Archaeological and Cultural Landscape Technical Review

Private Plan Change 23 (Whisper Creek)

John Messerly, May 2026

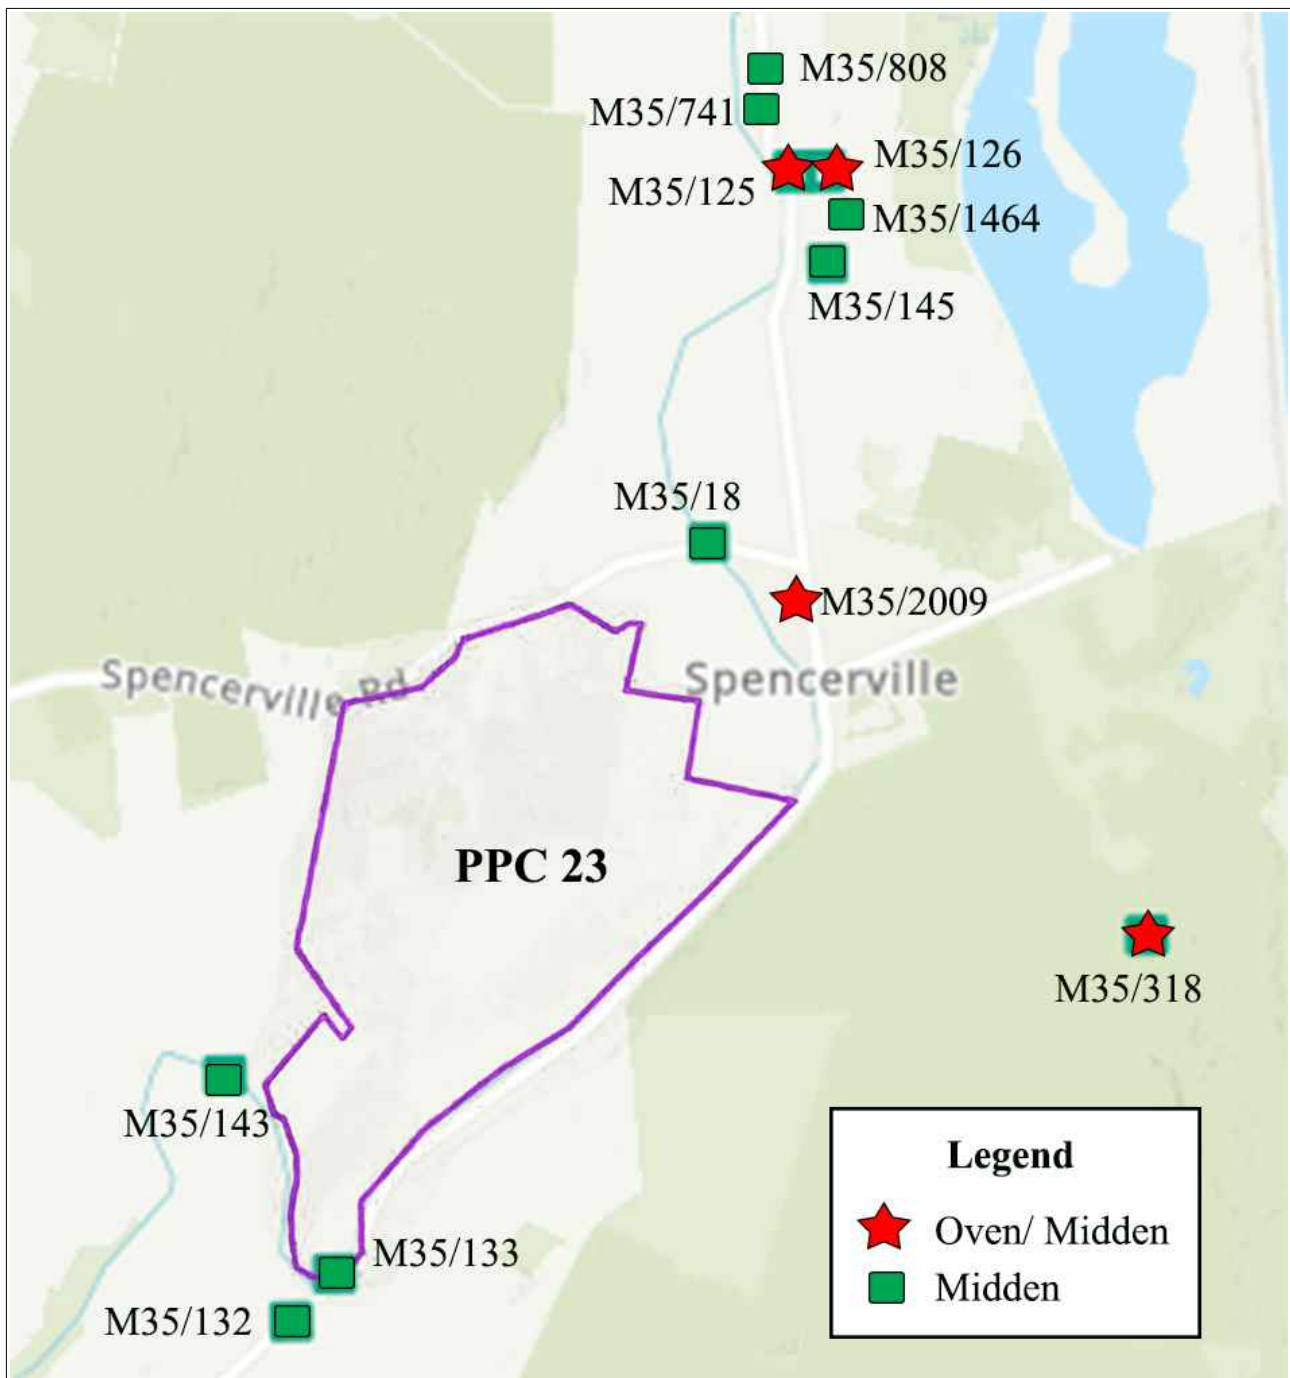
The presence of recorded midden site M35/133 partially within the PPC23 boundary materially weakens any inference that prior agricultural or landscape modification has eliminated archaeological survivability within the rezoning area. To the contrary, the spatial continuity of recorded midden sites immediately adjoining and intersecting the PPC23 footprint suggests that archaeological preservation within portions of the site remains plausible and cannot be dismissed through generalised assumptions regarding prior disturbance.

The absence of any apparent archaeological assessment addressing the immediate proximity of multiple recorded midden sites — including site M35/133's archaeological polygon extending partially within the PPC23 boundary — further limits confidence that archaeological effects and uncertainty have been adequately characterised at rezoning stage. Under those circumstances, the present evidential platform does not appear sufficiently complete to confidently exclude the possibility of materially greater archaeological and cultural landscape effects than presently assumed.
